SUBJECT: NuScale Power, LLC Responses to NRC Request for Additional Information No. 033 (RAI-10298 R1) on the NuScale Standard Design Approval Application

Response to Request for Additional Information Docket: 052000050

NRC Question No.: XPC.LTR-2

Figure 3: Boron Dilution Analysis Results – Reactor Component Cooling Water Line Break ^{(a),(c)}

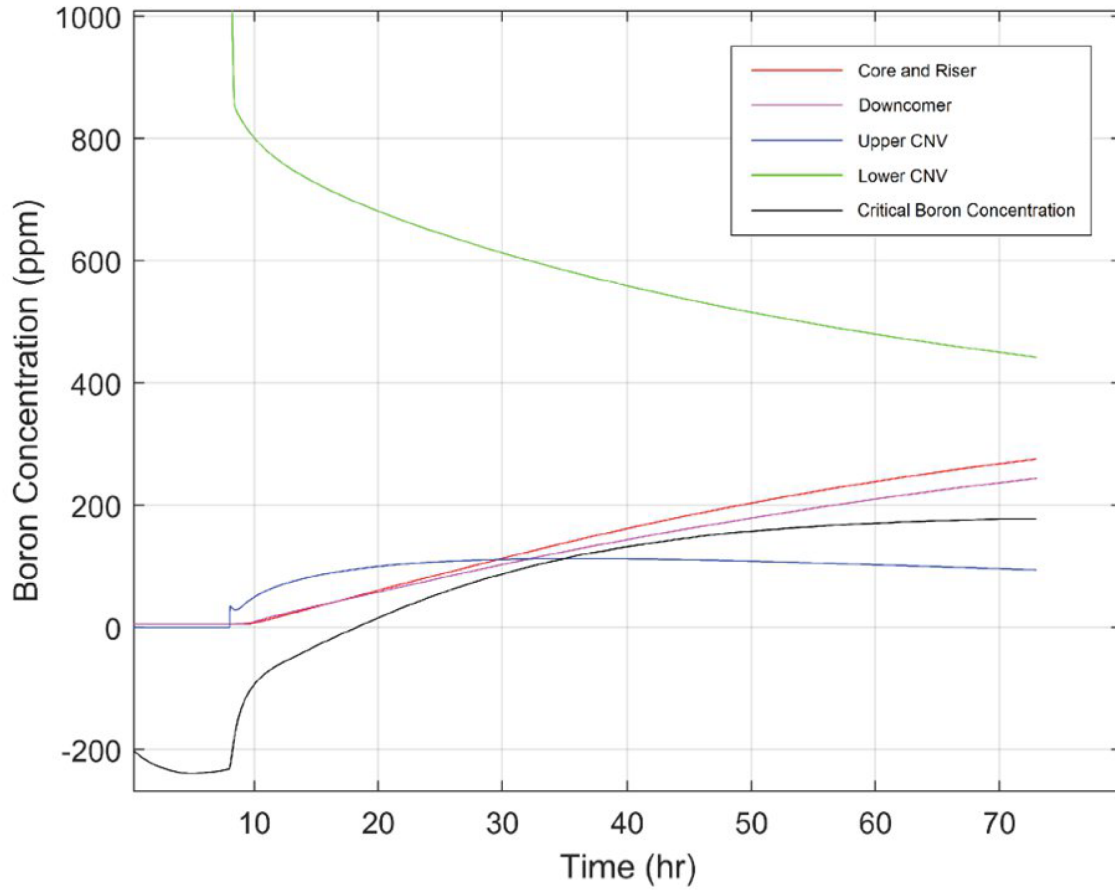
}}^{2(a),(c)} The gradients and flow patterns/behavior in the volumes should be validated analytically (such as through computational fluid dynamics). The analytical basis needs to account for the density difference between borated and pure water, because not accounting for the boron density leads to a result that is less conservative than a best estimate calculation. The density difference impact should be part of the validation methodology and uncertainties due to density and temperature should be quantified and the impacts on the figures of merit identified.

Graphical results of the boron dilution analysis of this event are shown in Figure 3 of this response.

- The green curve shows the lower CNV region has a high boron concentration before ECCS actuation at 8 hours, due to the RCCW dissolving the ESB into liquid and collecting below the RPV flange. After ECCS actuation at 8 hours, RPV blowdown adds dilute water (5 ppm) to the CNV, rapidly reducing the lower CNV concentration from above 1000 ppm to around 850 ppm. As the ESB directs condensate into the mixing tubes, some borated liquid in the the lower CNV region is displaced and transported to the upper CNV region, as shown by the downward trend in the green plot.
- The blue curve shows the upper CNV region boron concentration increasing due to displaced borated liquid from the lower CNV region after ECCS actuation. Boron in the upper CNV is then transported through the RRVs to the RCS downcomer, which feeds the core and riser. {{

}}^{2(a),(c)}, the upper region concentration is initially more than 500 ppm less than the lower region, and remains approximately 300 ppm less than the lower region at the end of 72 hours.

- The pink curve shows the RCS downcomer increasing due to boron transport from the upper CNV. {{

- The red curve shows the core and riser concentration increasing due to boron transport from the RCS downcomer.

- The black curve shows the critical boron concentration, which is influenced by changes in core reactivity due to RCS cooldown and changes in core isotopes (e.g., xenon). During DHRS cooling, the critical boron concentration changes relatively slowly as the moderator temperature cools and core isotopes evolve after shutdown. At 8 hours, ECCS actuation rapidly decreases the RPV pressure and temperature and the critical boron concentration increases rapidly as a result. By 10 hours the rate of change of pressures and temperatures decreases and the slow increase in boron concentration again relates primarily to the evolution of core isotopes (e.g. xenon decay).

The lower riser hole flow rates assumed in the boron transport analysis are biased low, which increases the difference between the core/riser and downcomer regions. The analysis results meet the acceptance criterion for subcriticality because the boron concentration in the RPV, both the core and riser volume (red curve) and the downcomer volume (pink curve), remain above the critical boron concentration (black curve). Higher riser hole flow rates would result in less difference between the core/riser and downcomer region concentrations.

As shown in Figure 3, the conservatisms in the boron dilution analysis are such that the {{

}}^{2(a),(c)}, which results in less boron transported to the core (lowering the red curve). {{

}}^{2(a),(c)}, which would result in more boron transported to the core (raising the red curve) and improve margin to the critical boron concentration.
